TECHNICAL SERVICE BULLETIN

REF.: ENGINE
NO.: EG92-002
DATE: FEBRUARY 28, 1992
MODEL: FJ

CONVERTER INSULATOR & FRONT EXHAUST PIPE

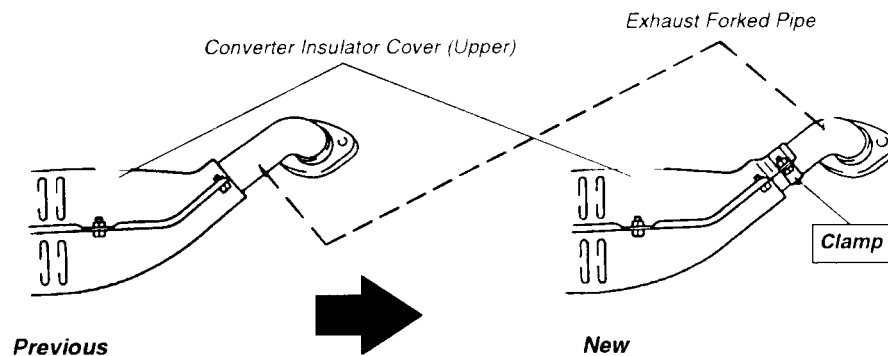
The Converter Insulator Cover and Front Exhaust Pipe have been modified to eliminate the possibility of rattling noise.

1. The shape of the upper Converter Insulator Cover has been changed as shown below:

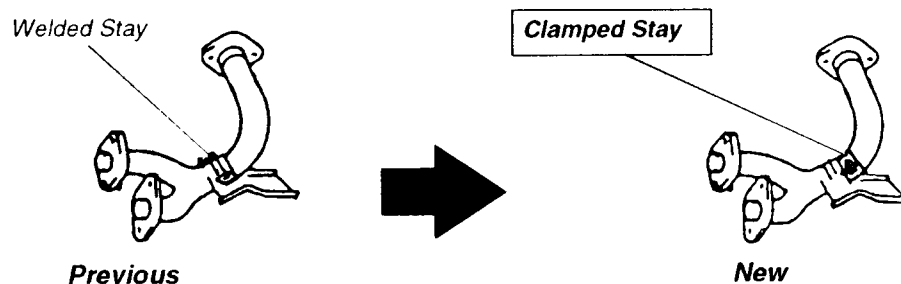
2. The method of installing the Upper Converter Insulator Cover on the Exhaust Forked Pipe has been changed as shown below.

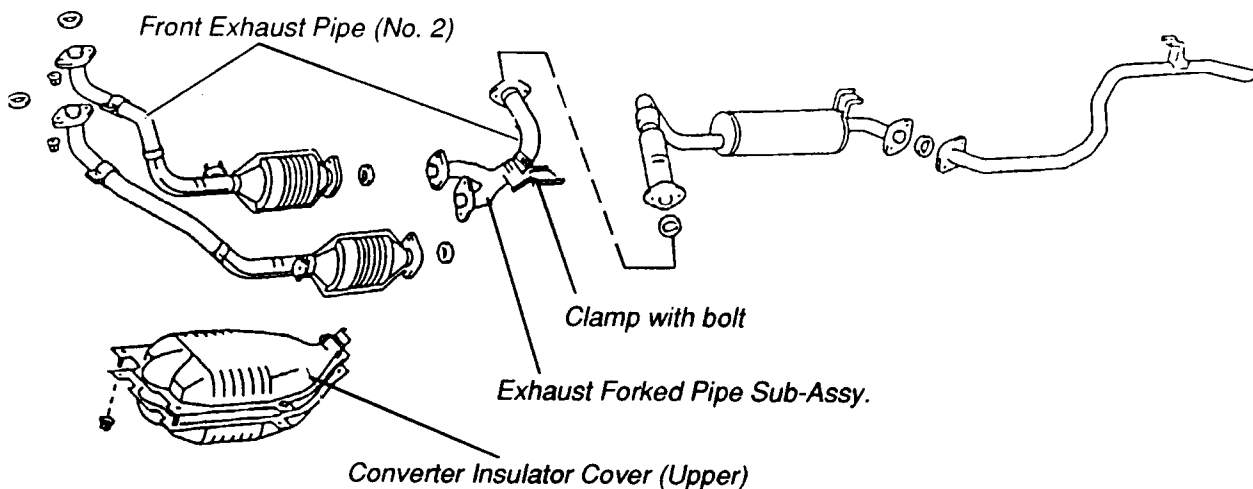
3. Modify original Exhaust Forked Pipe Sub-Assy. to the new design by cutting off the insulator cover stays and adding the clamp.

P/N: 17404-61020

P/N: 17404-61021

P/N: 90461-12342

P/N: 91511-60614
